Site Address: 9 BATESON CT SAC

Nature of Work: MP2444 2 STORY 10 RM SFR

SHELDON WHITEHOUSE - PHASE 2
CENTEX HOMES
PLOT PLAN FOR LOT 45

Centex Homes
Serenade Subdivision Lot 245

Job	Truss	Truss Type	Qty	Ply	VALID FOR TRUSSES A18 AND A19. (optional)
H2-049	A18-A19	CAL HIP	2	1

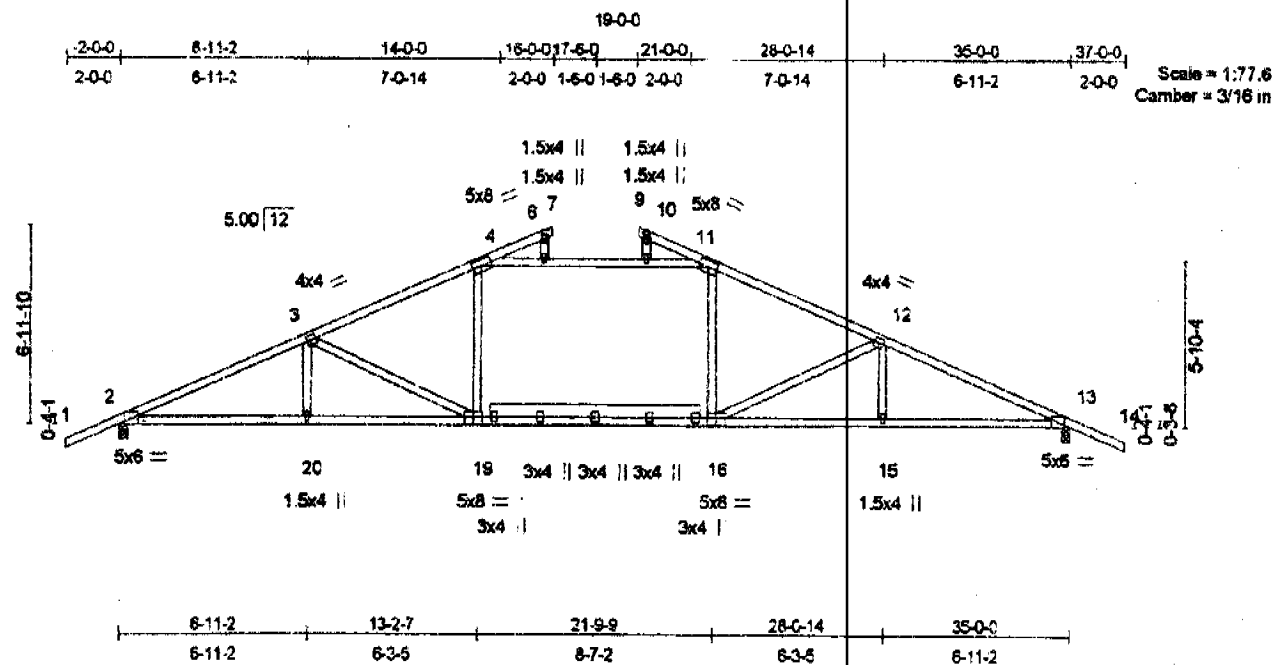
The extended top chord portion of Trusses A18 and A19 (the sloping top chord extending above the flat top chord section at J4 or J11) may be field trimmed as required to accommodate a hip corner rafter or other framing member.

The flat section may not be modified in any manner.

Truss	Truss Type	City	Ply
H2-049	A20R	CAL HIP	1 2

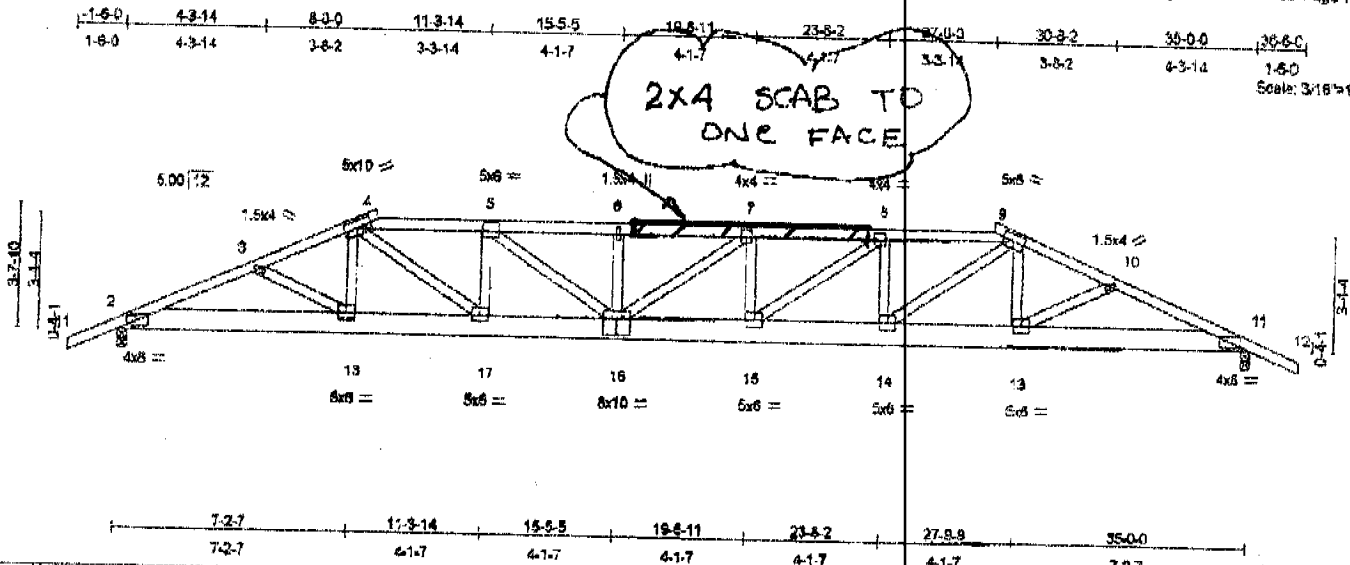
RE: PLAN 2444 A / - RUS A20

- REPAIR NOTES:**
 - Truss repair calculations based on information from fabricator/contractor whose responsibility it is to verify the adequacy of repair as to its field application. Return all joints to original position before applying repair. The end distance, edge distance, nail spacing, and size of plywood gussets and/or truss members shall be such as to avoid splitting of the wood.

- Refer to original engineering for plating information not shown.
 - Field-fit 2x4 #1&Btr DF 8-0" scab to one side of top chord centered on joint 7, attach using 10d nails staggered at 4" o.c. Obtain wood-to-wood tight fitting joints.
